Re: Preliminary & Final Plats – H Block (16-051AFDP/PP/FP)

Summary

This is a request for approval of a Preliminary and Final Plat of an approximately 5.05-acre site into three lots (Lots 10, 11 and 12) and right-of-way for two streets (Mooney Street and Larimer Street) for the development of 6 townhome buildings.

CITY OF DUBLIN, FRANKLIN COUNTY, OHIO
 QUARTER TOWNSHIP 2 & 3, TOWNSHIP 2, RANGE 19
 UNITED STATES MILITARY DISTRICT
 PRELIMINARY PLAT
 FOR
BRIDGE PARK BLOCK H
 2016

TEMPORARY DALE-TULLER CONNECTOR ROAD (PUBLIC STREET) - INTERIM CONDITION

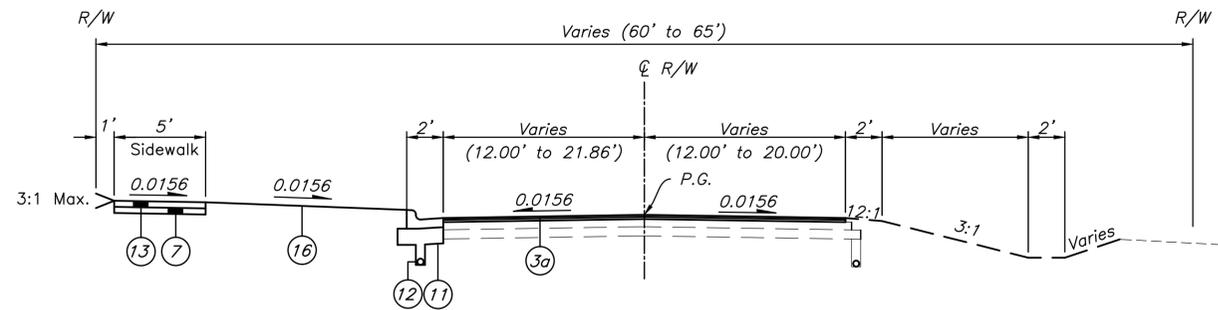
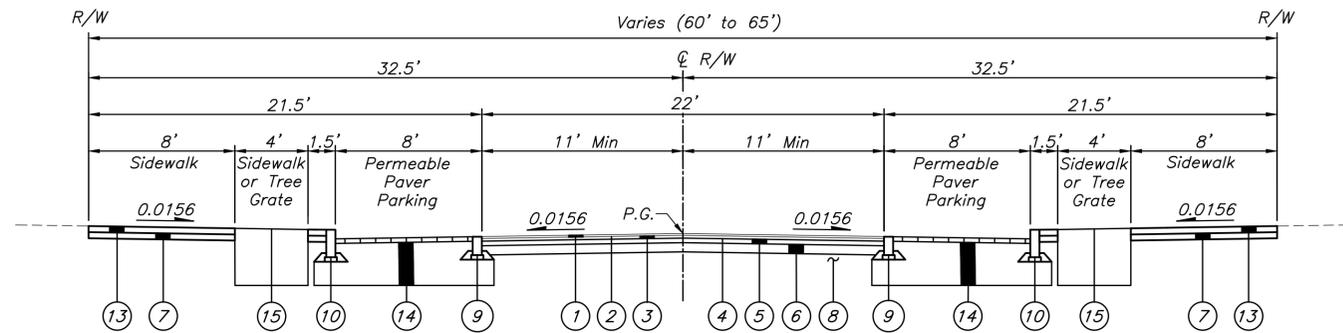
- 1) That the applicant ensures that any minor technical adjustments to the plat are made prior to City Council submittal, and;
- 2) That the applicant coordinate the treatment of the Dale Drive frontage of this block with staff and revise the street section in the preliminary plat accordingly prior to submission to City Council.

Details	Preliminary/Final Plat
	<p>The street sections included in the preliminary plat show a temporary condition for Dale Drive (Dale-Tuller Connector Road) which includes a five-foot sidewalk and a ditch along the block frontage. The typical street section shown is insufficient. This area need to be reworked to remove the open ditch along the frontage, and shall include typical Bridge Street component's, including, but not limited to:</p> <ul style="list-style-type: none"> • Wide pedestrian paths that extend to the back of the curb. • On street parking spaces. • New curb where necessary. • Street trees, planters and other streetscape elements. • Other streetscape elements needed to meet the streetscape standard of the District. <p>The applicant will be required to coordinate the treatment of the Dale Drive frontage of this block with staff and revise the street section in the preliminary plat accordingly prior to submission to City Council.</p>

The applicant has met both conditions for the preliminary and final plats.
